SUBJECT: Provides response to NRC request for addl info re svc water
 sys.Responses,together w/commitments made & info provided
 throughout insp period provided sufficient detail to support
 closure of issues raised during insp.

Subject: Additional Information-Service Water System
R.E. Ginna Nuclear Power Plant
Docket No. 50-244

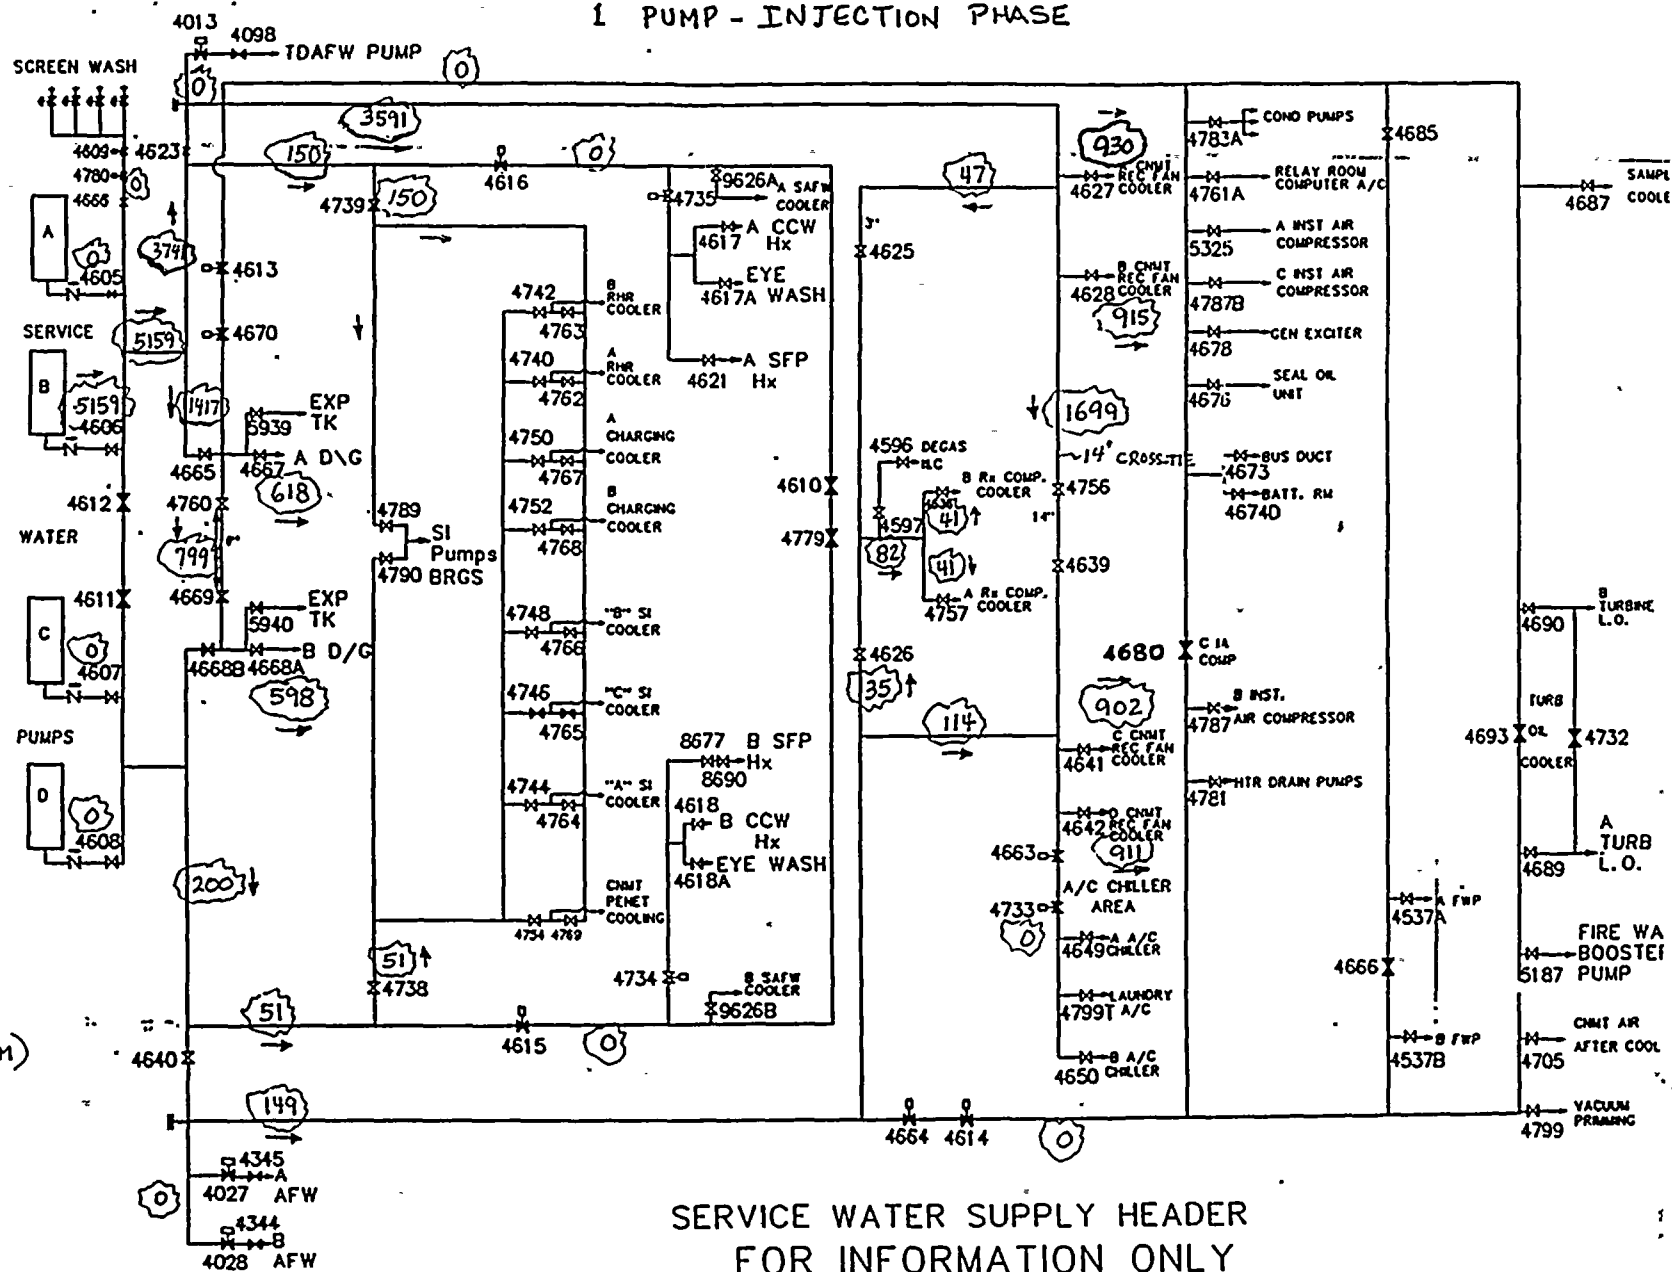
"Based on recent test results using the most limiting service water pump (corrected for worse-case lake level, water temperature, instrument inaccuracies, and pump degradation allowed under the inservice testing program), annotate on a simplified diagram of the SWS the pump discharge pressure, flow rates through each safety-related component, flow rates through non-safety-related supply lines (as applicable), and the system configuration/alignment that is necessary to satisfy the flow requirements for safety-related equipment. Also, indicate the electrical division (A, B or non-safety-related) where each component receives power. Describe how this system configuration/alignment will be achieved during an event assuming off-site power is available and also for the condition where off-site is not available, and identify specific time constraints that must be met in order to satisfy all accident analyses assumptions for heat removal. Provide conservative estimates of how long it will take to complete necessary actions for each case (i.e., off-site power available and off-site power not available). The basis for these estimations should be provided, which may include reference to previous plant experience, plant simulations and exercise walk-throughs."

The attached figures depict on a simplified diagram of the service water supply system the flows to the service water loads for the two cases of interest:

- 1) Injection phase, loss of offsite power, 1 service water pump
- 2) Recirculation phase, loss of offsite power, 1 service water pump

Our analysis of various system configurations were conducted using the enhanced service water system hydraulic computer model, Kypipe. The two cases above were examined in order to determine the minimum service water flow to the containment recirculation fan coolers (CRFC) with only one service water pump operating. These values became an input to our accident analysis performed for the one service water pump case reported in our letter dated September 1, 1992.

System runs were made in order to determine sensitivity to the service water header in operation and to produce the least flow through four fan coolers when only one service water pump is operating. For the injection phase the CRFC flow, including the cooling flow to the electric drive motor cooling coils, is approximately 900 gpm. Subtracting the motor cooler flow resulted in a CRFC flow of 840 gpm, the value used in the analysis. (See Question No. 3). Flow values for each of the separate smaller lines, such as safety injection pump bearings, and safety related pump area coolers have not been shown on the diagram individually, since their total does not represent a large load. The flowrates meet or exceed those typical values listed in UFSAR table 9.2-2 for the cases examined.
